Three Mile Island Nuclear Station, Unit 1  
Facility Operating License No. DPR-50  
NRC Docket No. 50-289

Subject: Technical Specification Change Request No. 335 – Reactor Coolant System  
Pressure-Temperature Safety Limit

**TMI Unit 1 Technical Specification Change Request No. 335**

**Revised Technical Specifications & Bases Pages**

CORE PROTECTION SAFETY LIMIT  
TMI-1  
FIGURE 2.1-1

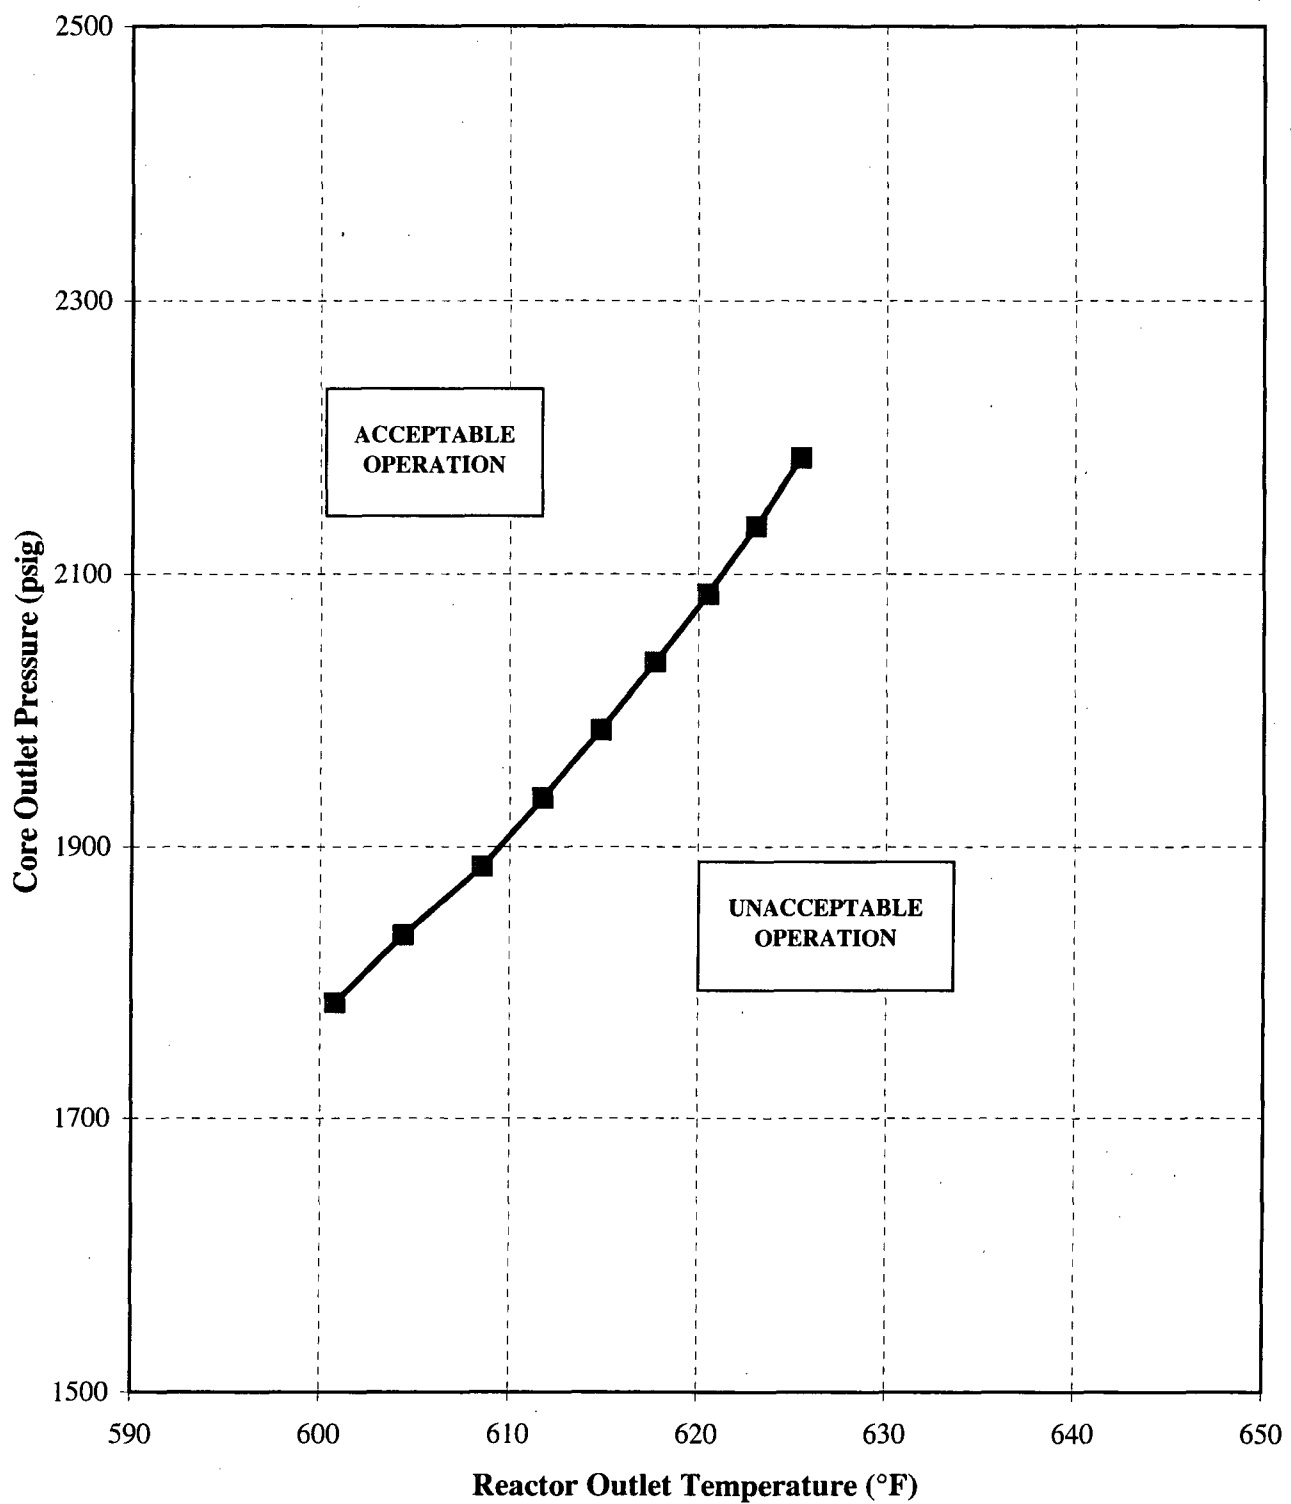
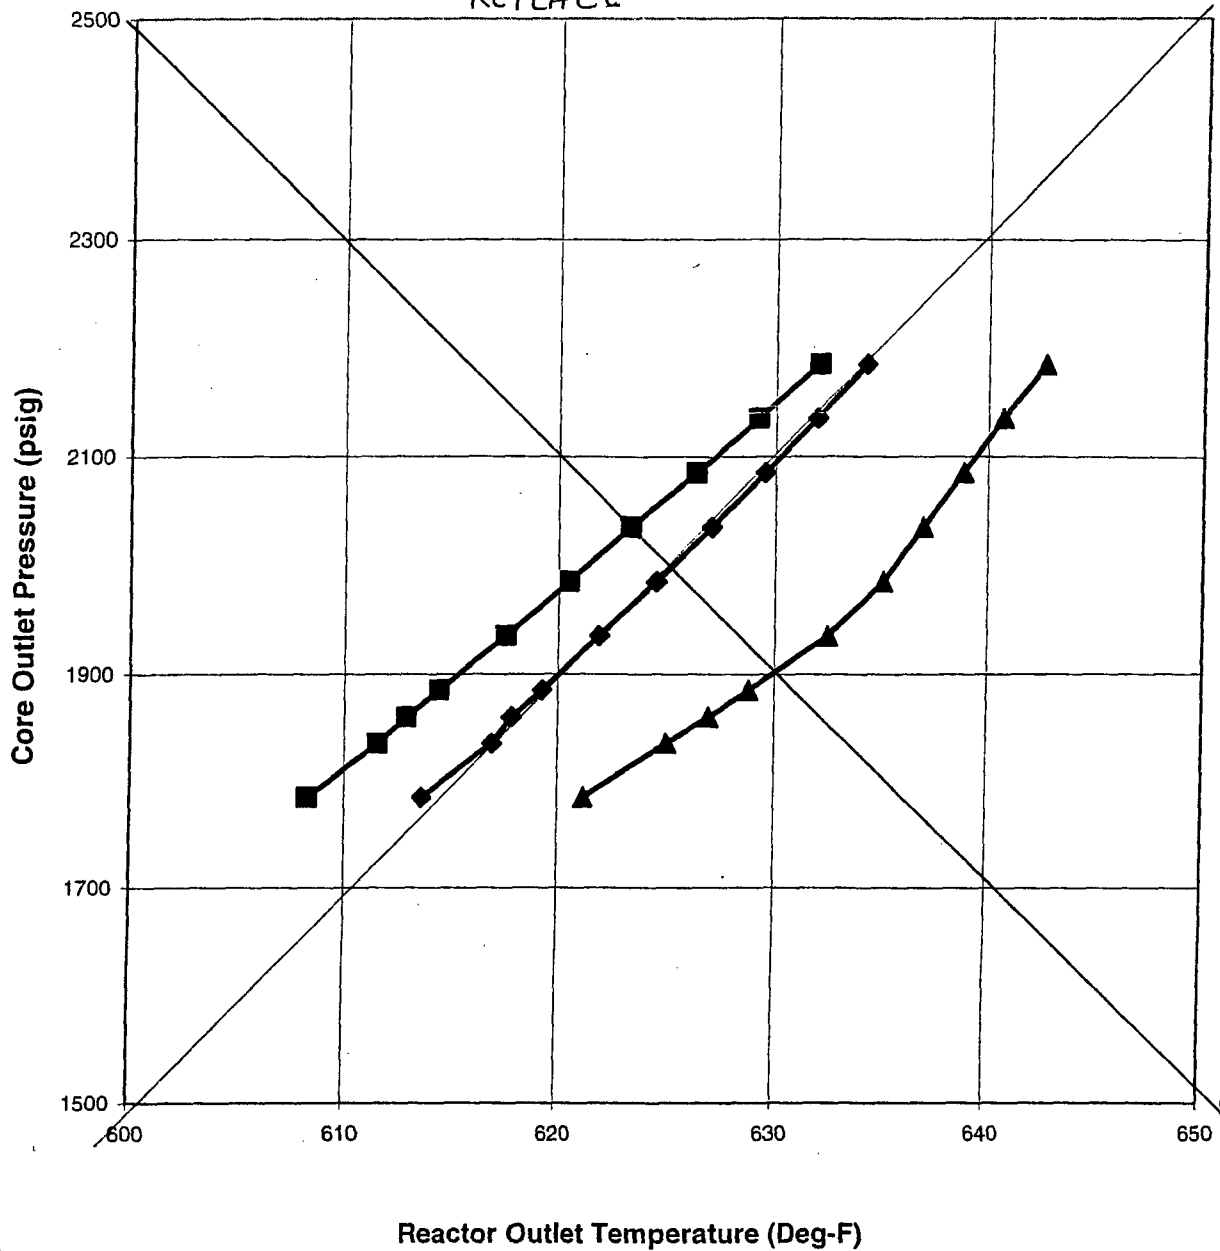
- 2.2 The Core Protection Safety Limit specified in TS Figure 2.1-1, Core Protection Safety Limit, and Bases Figure 2.1-3, Core Protection Safety Bases, are modified to incorporate a revised limit based on the implementation of the Mark-B-HTP fuel design in Cycle 17.

In conclusion, implementation of the Mark B-HTP fuel design for Cycle 17 requires adoption of a more conservative safety limit curve to maintain the same magnitude of DNB protection. Therefore, TS Figure 2.1-1, Core Protection Safety Limit, requires revision. The change to the core protection safety limit curve requires a related change

CORE PROTECTION SAFETY BASES  
TMI-1  
FIGURE 2.1-3

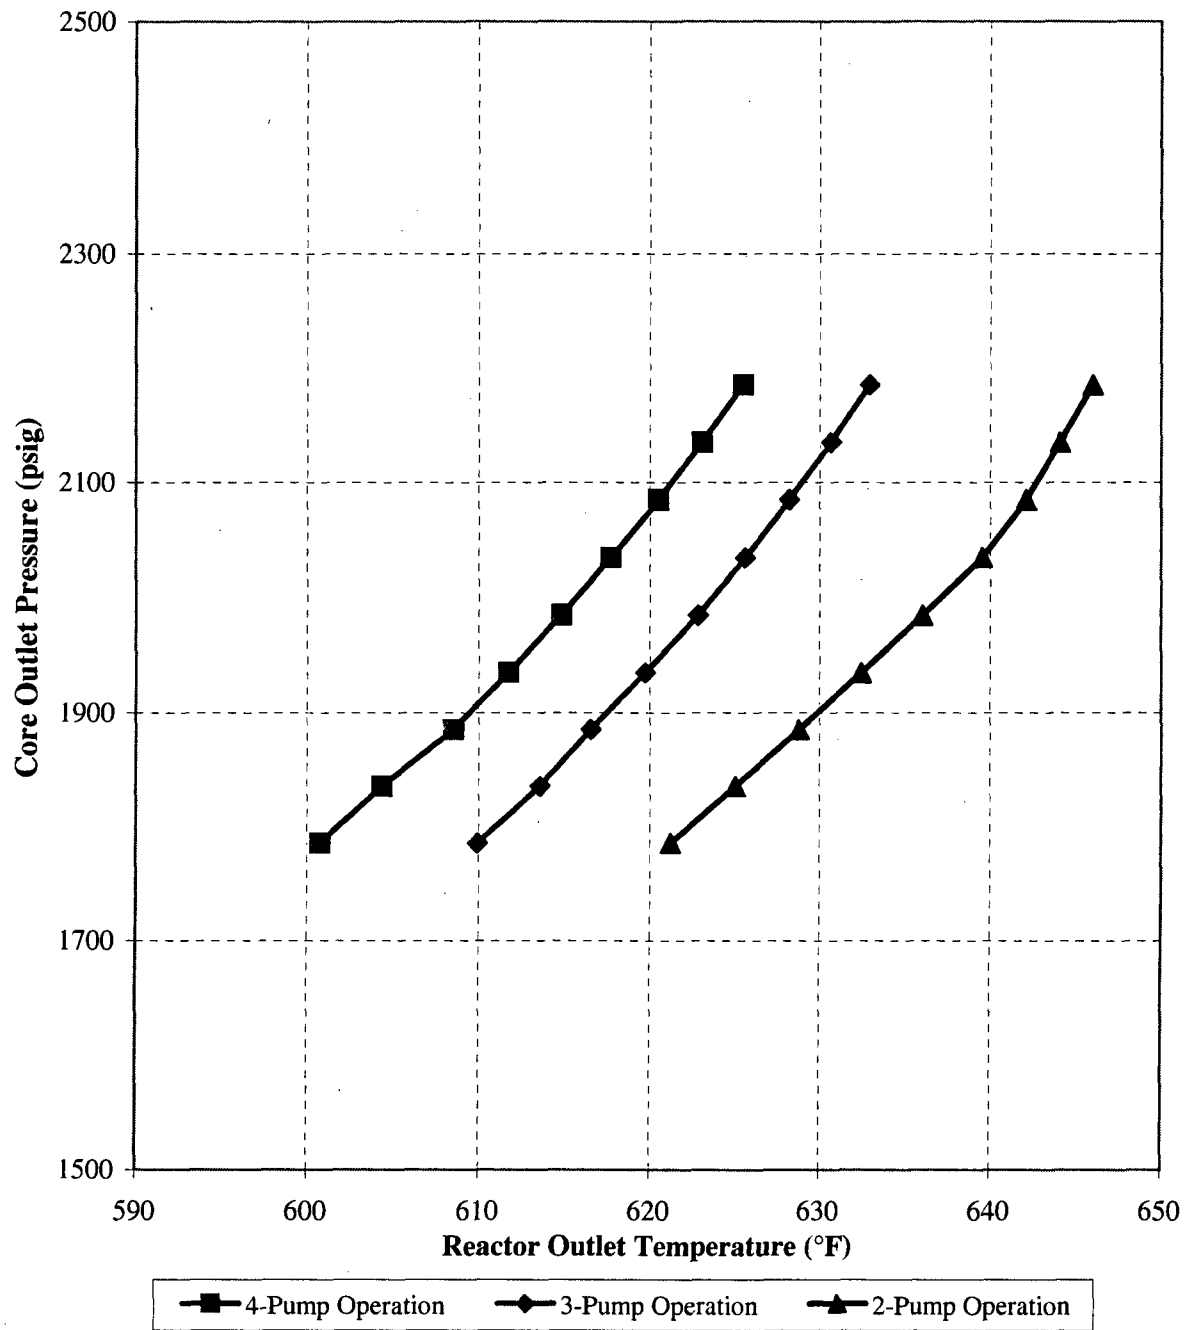
The curve of Figure 2.1-1 is the most restrictive of all possible reactor coolant pump-maximum thermal power combinations shown in Figure 2.1-3. The curves of Figure 2.1-3 represent the conditions at which the DNBR limit is predicted at the maximum possible thermal power for the number of reactor coolant pumps in operation or the local quality at the point of minimum DNBR is equal to ~~22 percent (BAW-2) or 26 percent (BWC)~~ whichever condition is more restrictive. The curves of Figures 2.1-1 and 2.1-3 were developed assuming a reactor coolant design flow rate of 102% of 352,000 gpm.

TABLE 2-3-1

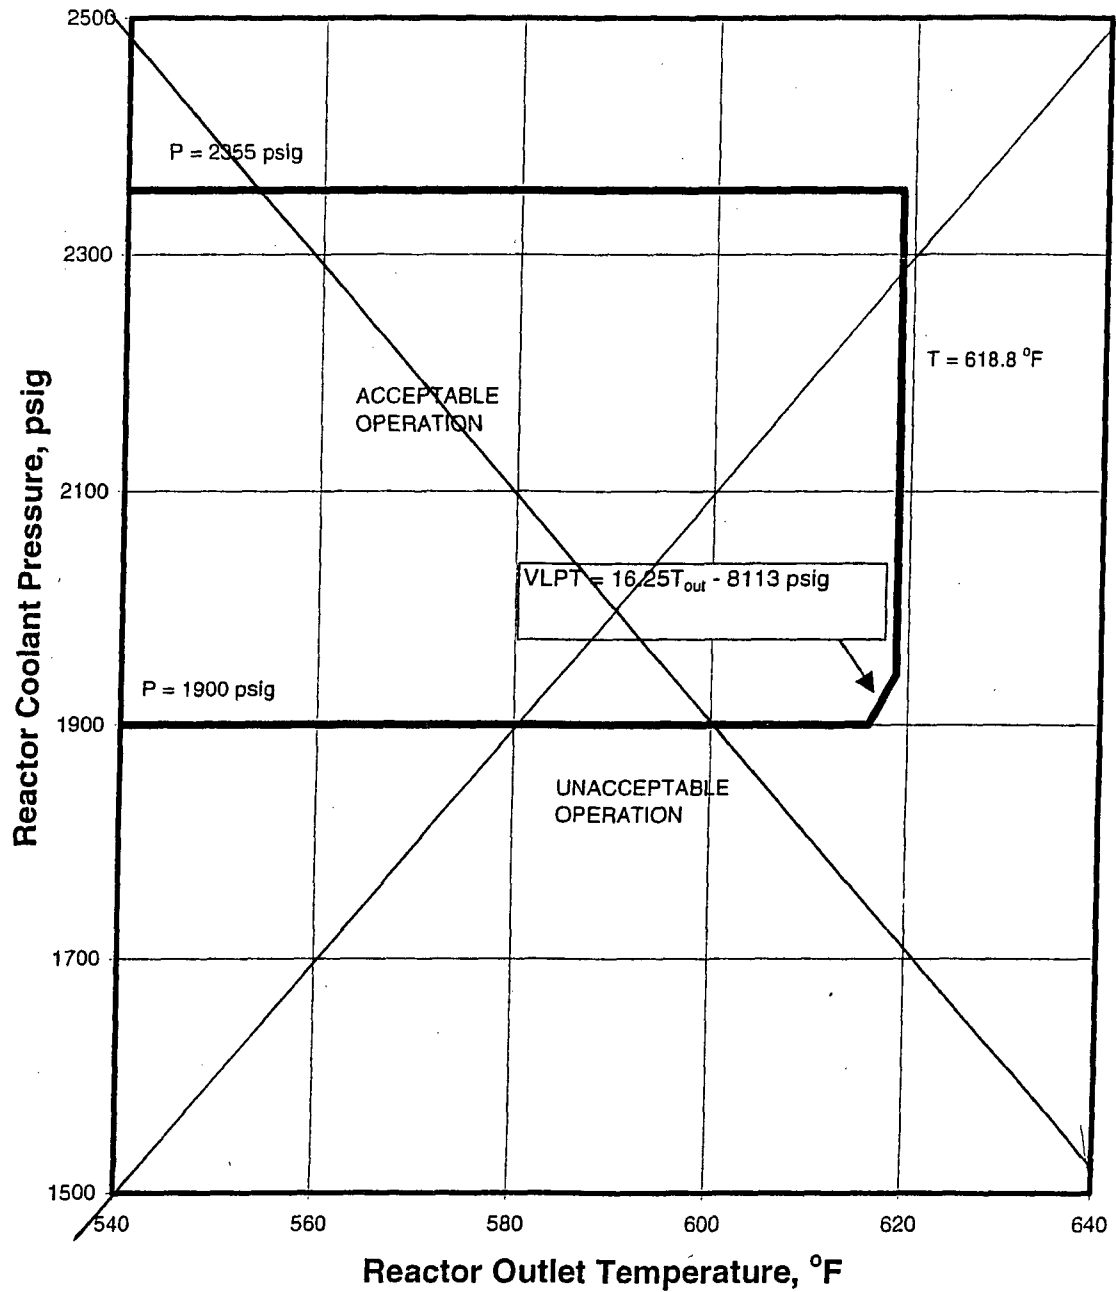
- 2.3 TS Table 2.3-1, Reactor Protection System Trip Setting Limits, and Figure 2.3-1, Protection System Maximum Allowable Setpoints, are modified to revise the variable low pressure trip setpoint to reflect implementation of the Mark-B-HTP fuel design in Cycle 17.

$$(16.21 T_{out} - 7973)(6)$$

PROTECTION SYSTEM MAXIMUM  
ALLOWABLE SETPOINTS  
TMI-1  
FIGURE 2.3-1

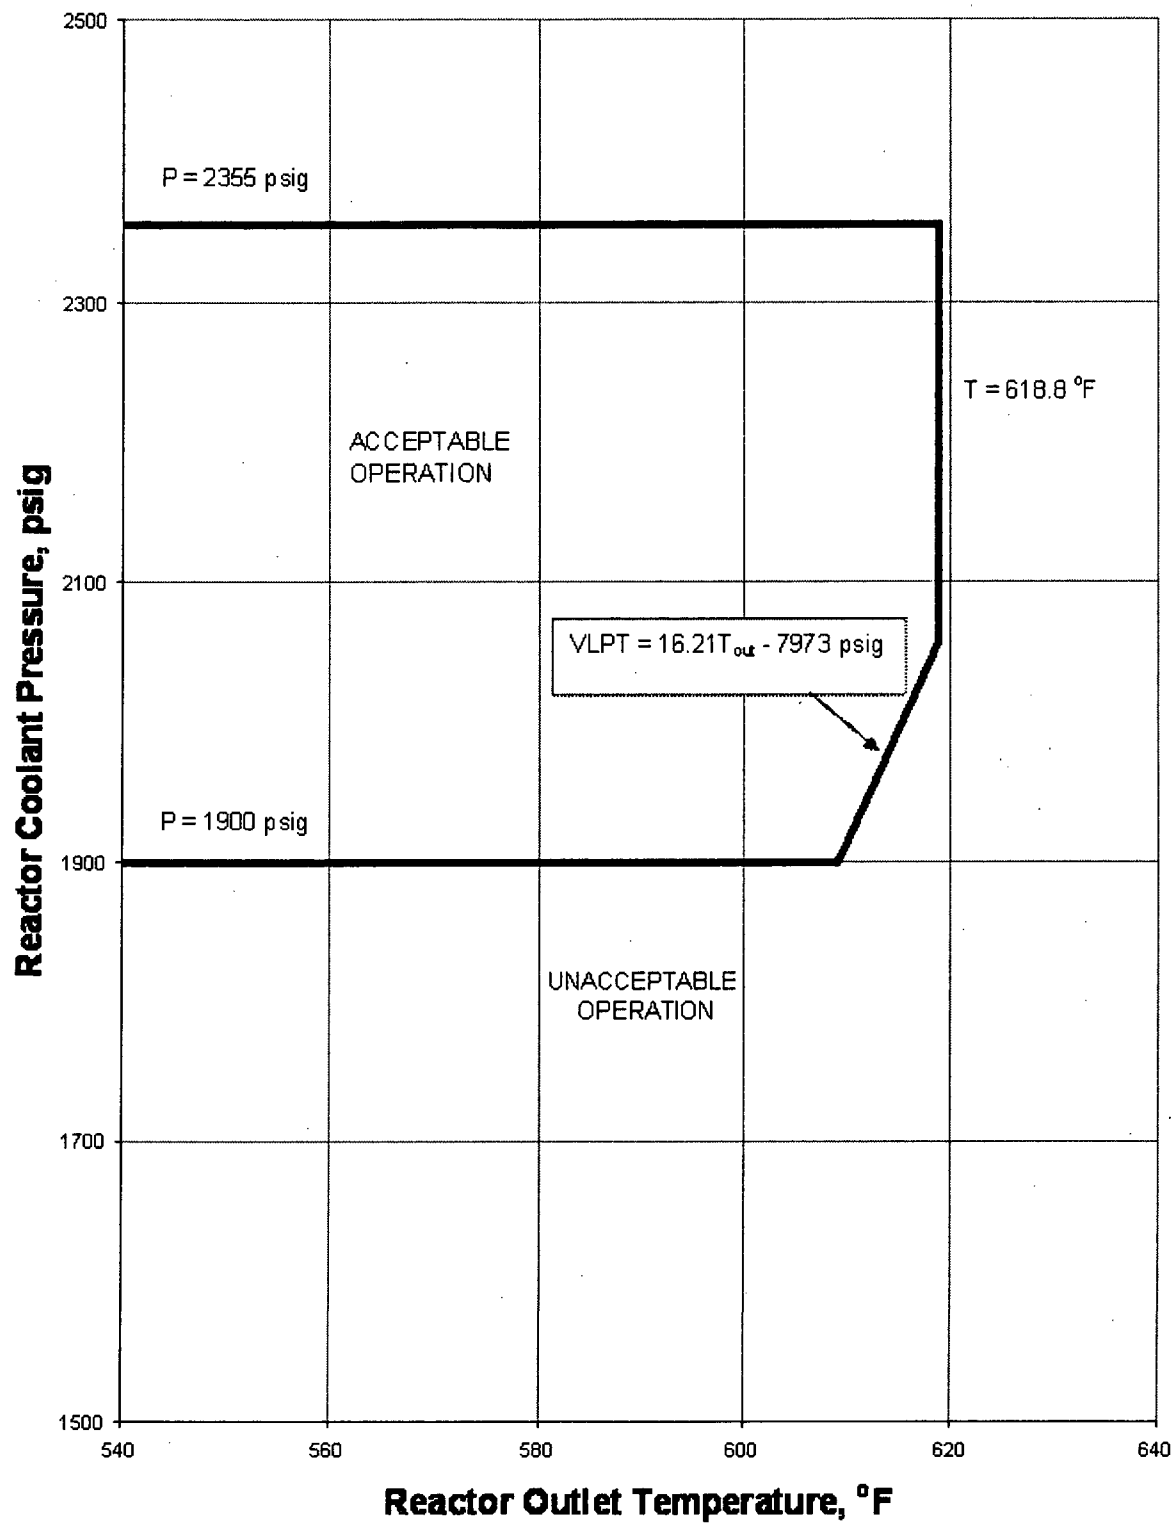
to the variable low pressure trip setpoint. Therefore, TS Figure 2.3-1, Protection System Maximum Allowable Setpoints, and TS Table 2.3-1, Reactor Protection System Trip Setting Limits, require revision. Variable low pressure trip setpoint surveillance requirements, established in accordance with NRC RIS 2006-17, "NRC Staff Position on the Requirements of 10 CFR 50.36, "Technical Specifications," Regarding Limiting Safety System Settings During Periodic Testing and Calibration of Instrument Channels," dated August 24, 2006, require the addition of pre-defined acceptance criteria to TS Table 4.1-1, Instrument Surveillance Requirements. The proposed changes to the TMI Unit 1 TS have been established to assure adequate margins of safety are maintained and have been developed in accordance with NRC-approved codes and methodologies. Therefore, the proposed changes do not adversely affect nuclear safety or safe plant operations.
